DETENTION BASIN STAGE-STORAGE TABLE BUILDER

Project: Ellicott Town Center

Basin ID: Pond C2.8

EAST SITE / FILING NO. 2 DEVELOPED DRAINAGE PLAN

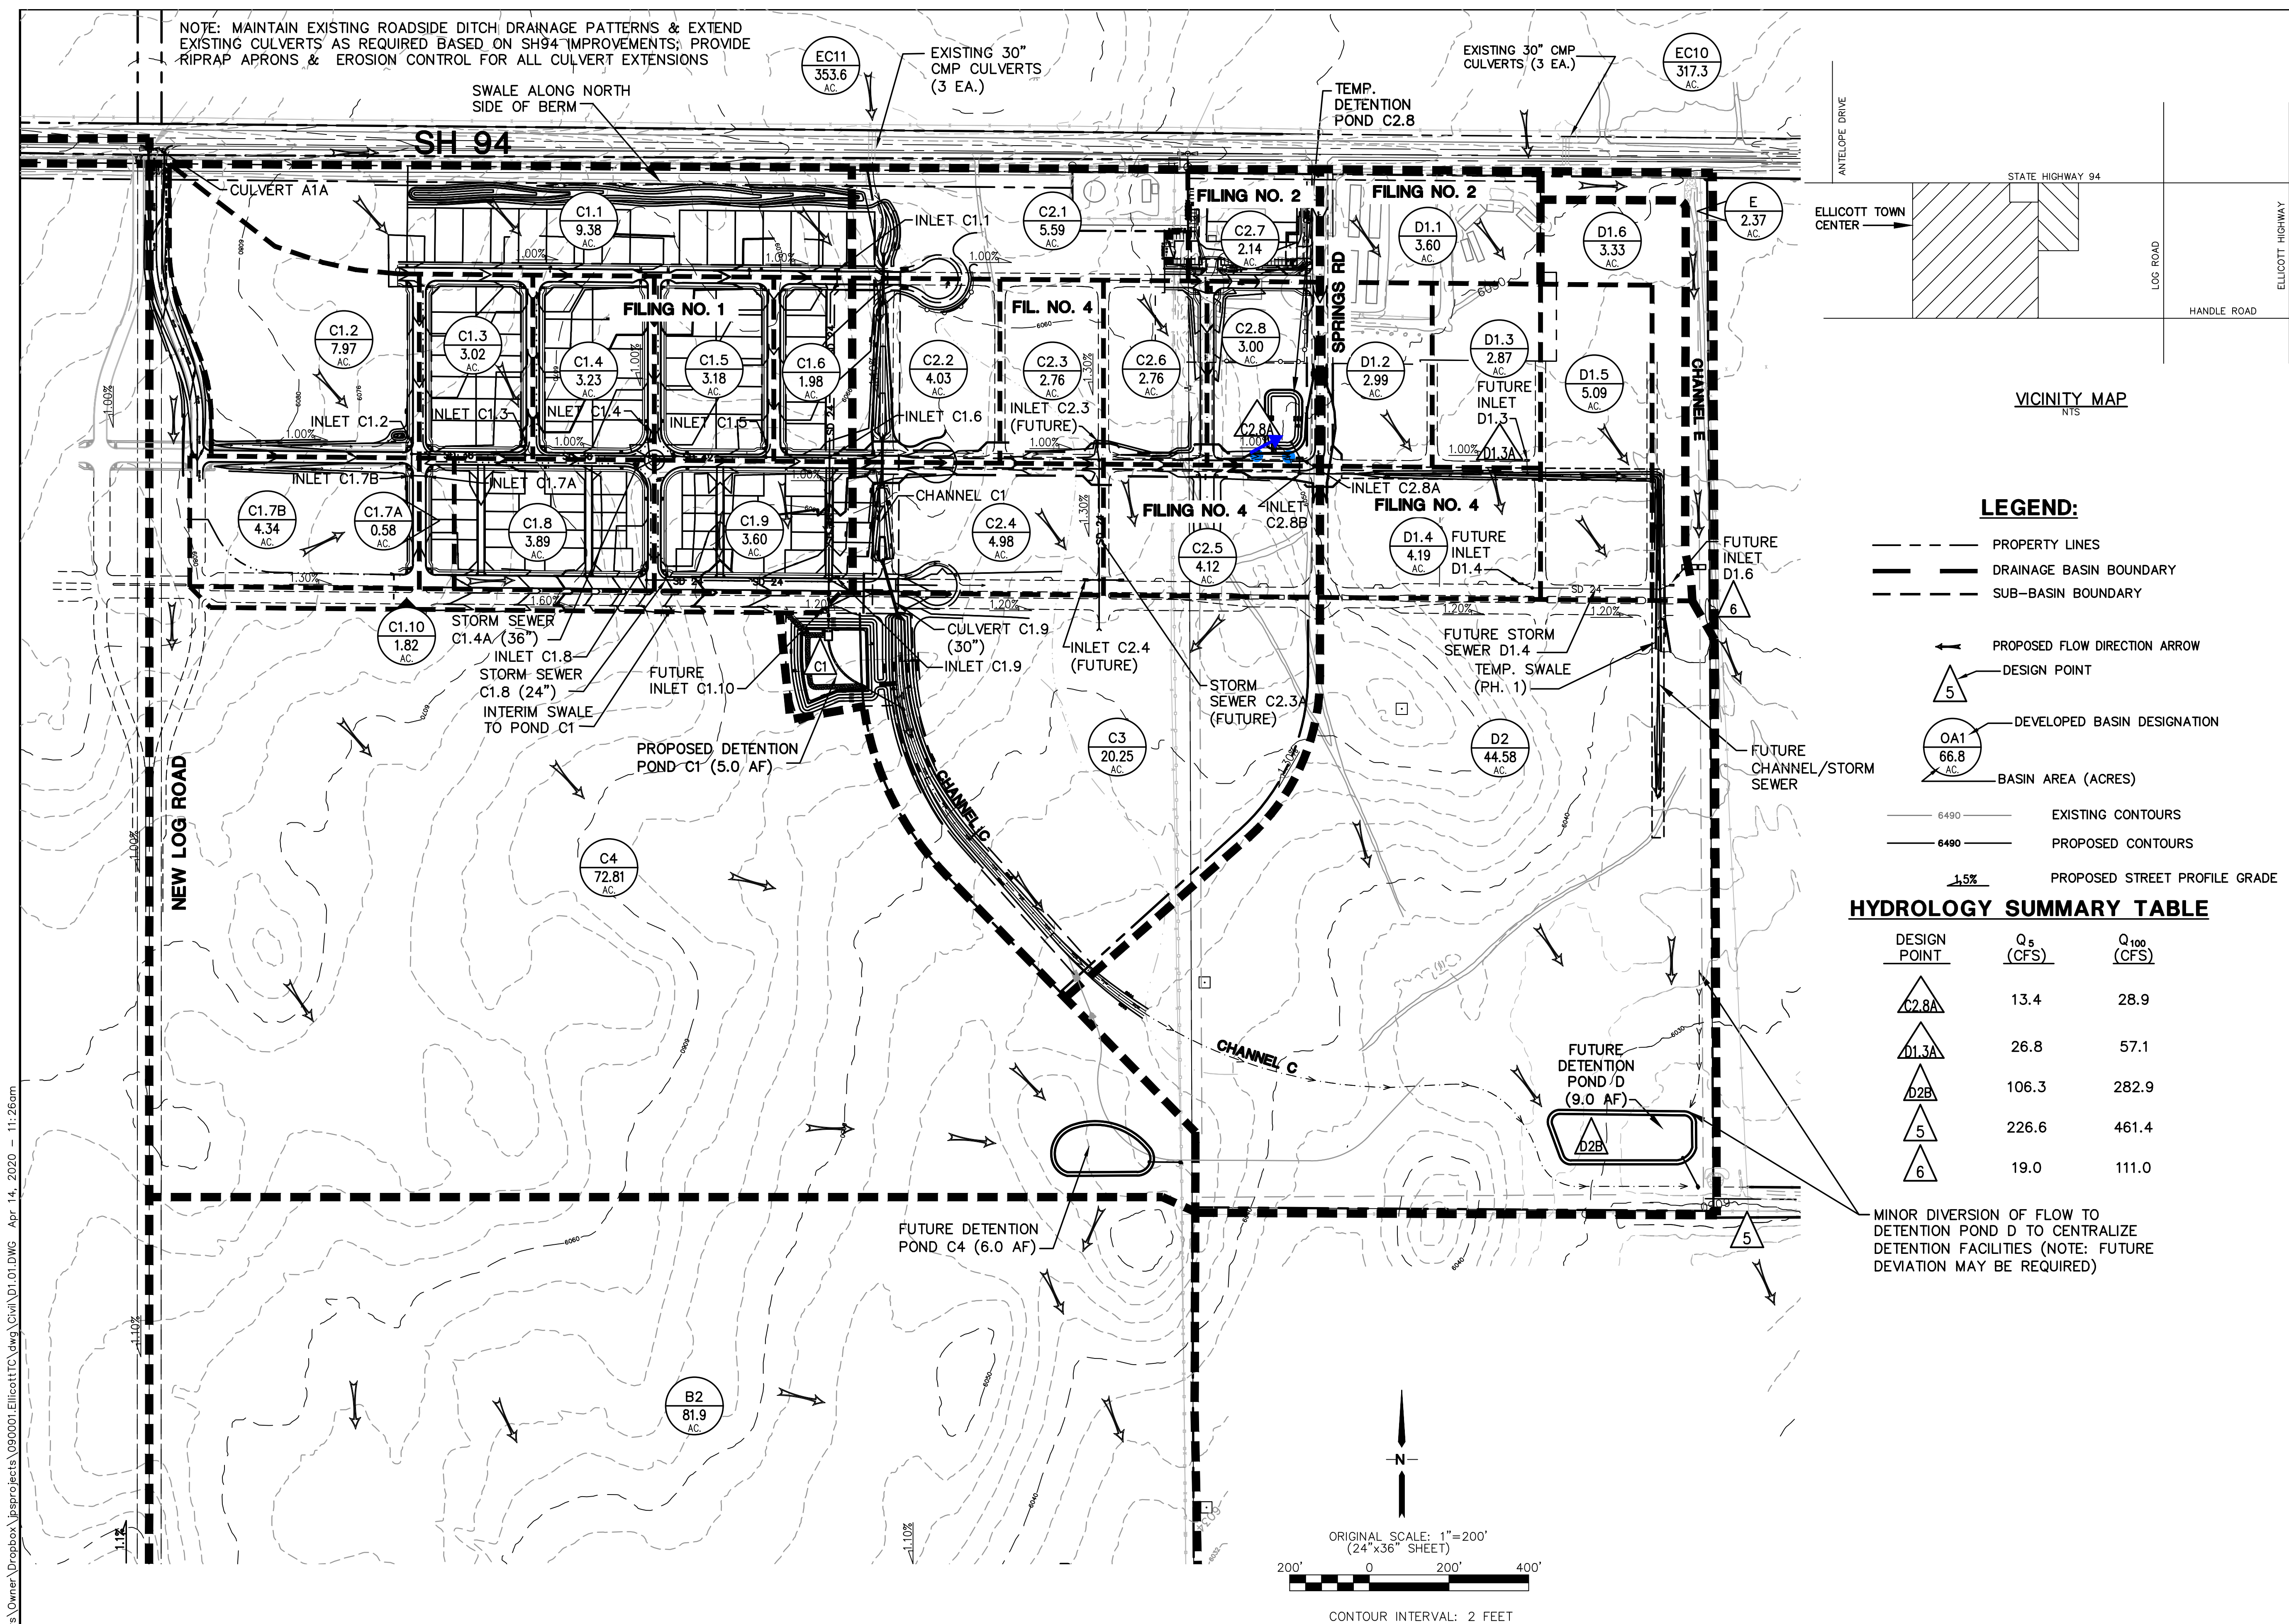
Is this old or a duplicate?
